ADDENDUM NO. 3

BARNSTABLE

Intersection Improvements and Related Work (Including Signals) at Iyannough (Route 28) and Yarmouth Roads

Transmitting changes to the Contract Documents as follows:

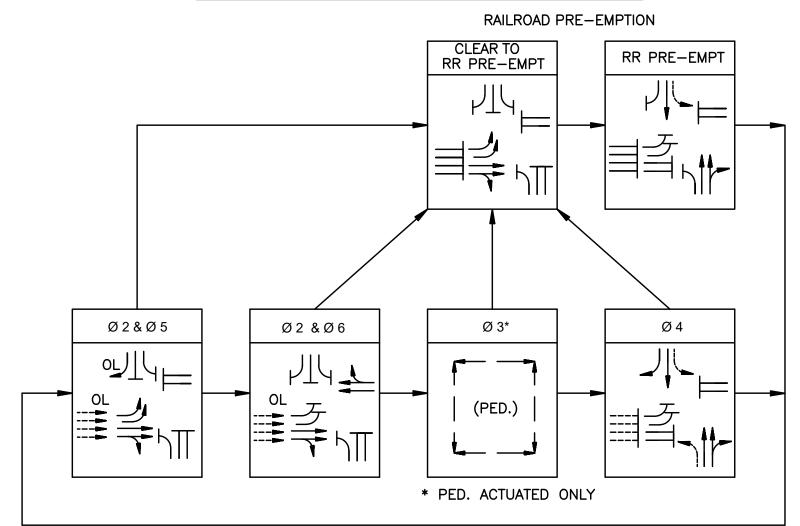
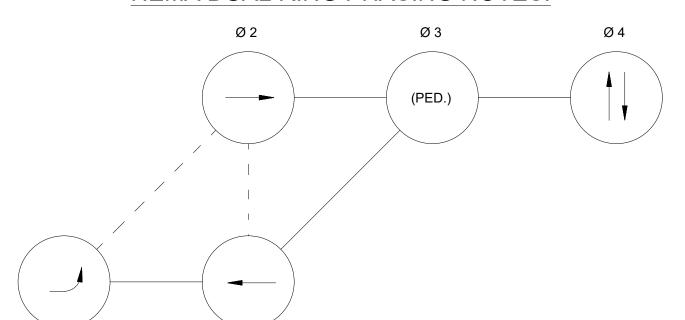
3 5. FOR SIGNAL HEAD P, Q, R, AND S, CHANGE FLASHING YELLOW INDICATIONS ON EXISTING SIGNAL HEADS FOR STEADY GREEN
